<b>AMENDMENT OF SOLICITATION/MODIFICATION OF CONTRACT</b>		1. CONTRACT ID CODE		PAGE OF PAGES 1   2	
2. AMENDMENT/MODIFICATION NO. A00001		3. EFFECTIVE DATE SEE BLOCK 16C		4. REQUISITION/PURCHASE REQ. NO. W45XMA91224061	
5. PROJECT NO. (If Applicable)		6. ISSUED BY Albuquerque District		7. ADMINISTERED BY Albuquerque District	
8. NAME AND ADDRESS OF CONTRACTOR (No., Street, County, State, and Zip Code) Koman Construction, LLC 2700 Gambell St Ste. 401 Anchorage AK 99503 USA		9A. AMENDMENT OF SOLICITATION NO.		9B. DATED (SEE ITEM 11)	
CODE		FACILITY CODE		10A. MODIFICATION OF CONTRACT/ORDER W9126G19C0025 NA	
				10B. DATED (SEE ITEM 13) 06 May 2019

Contract for El Paso Modular CPC.

Reference No. R00001  
 00001 Changes to Bldg. & Site

**A. SCOPE OF WORK****00001 Changes to Bldg. & Site**

N  
SITE GRADING PLAN  
C-101  
SCALE: 1" = 40'

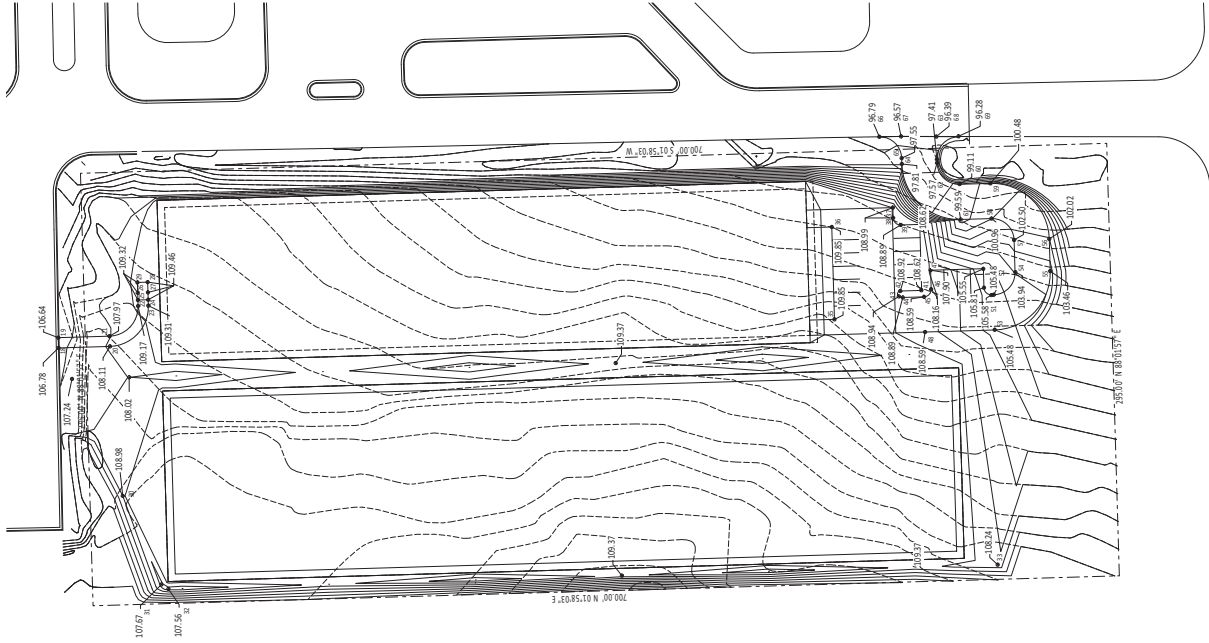
Refer to file 19C0025\_0001\_SKT\_115May19.pdf and provide design, supervision, labor, material, and equipment for reductions and additions as marked up in the file.  
A listing of reductions and additions (not all inclusive) associated with referenced file as follows:

Water heaters, toilets, lavatories, janitor sinks, PEX hot water supply lines from water heaters, PEX cold water supply to water heaters, 30 AMP breakers to water heaters, electrical wiring to water heaters, partition walls, elimination of janitor's closets, and elimination of doors.

Electrical pedestal, service panel 400 AMP, terminations/connectors, rigid conduit installed underground (UG), 2 inch water line PVC, hose bib, 4 inch waste lines, and 2 ft. x 2 ft. hand boxes.

SHEET TITLE:	
ENLARGED PARTIAL FLOOR PLAN AT HOLDING POD #3	
SHEET NO.	
A-104	
SHEET	20 OF 29

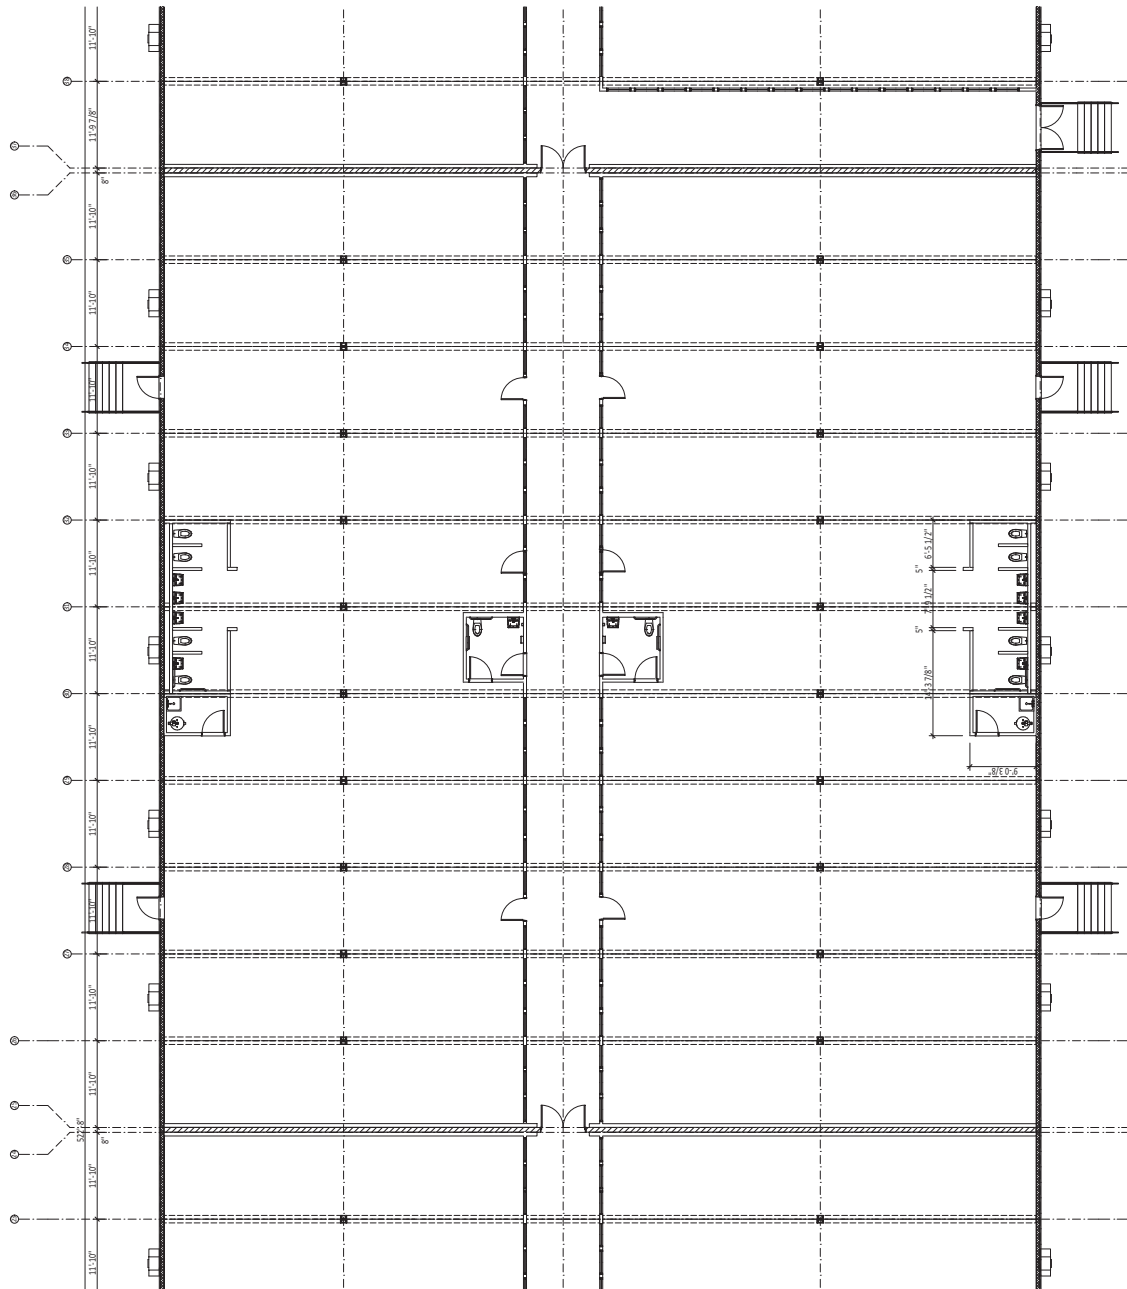
See comments on LS-101

SHEET NO. A-105	SHEET 21 OF 29
-----------------	----------------

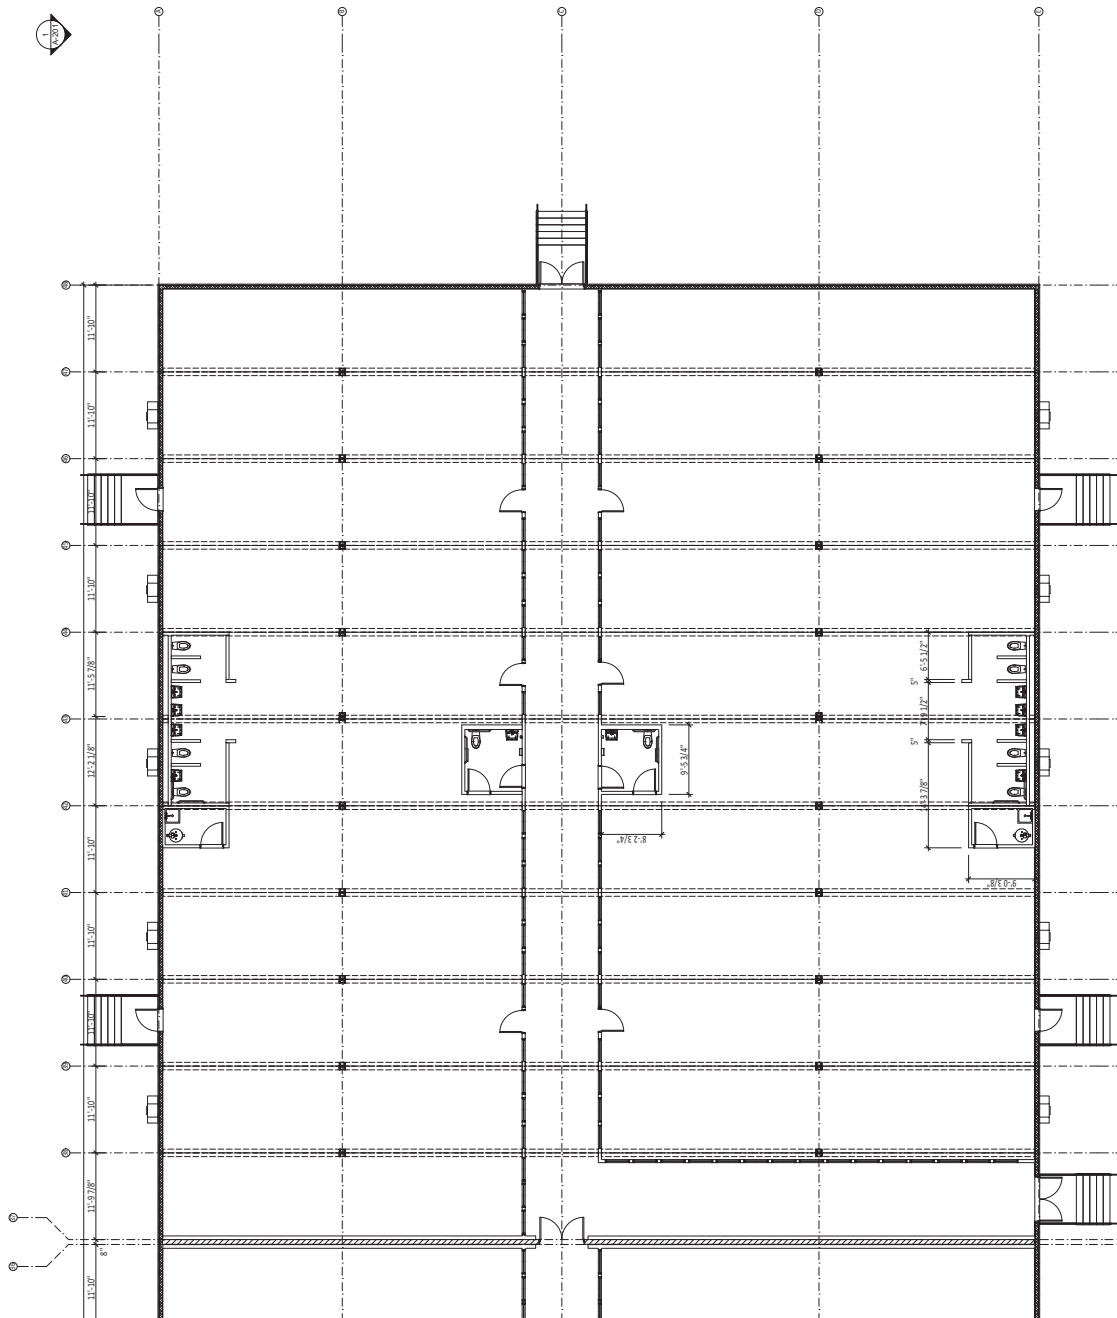
See comments on LS-101

Independent  
RTU HVAC for  
corridor not  
shown
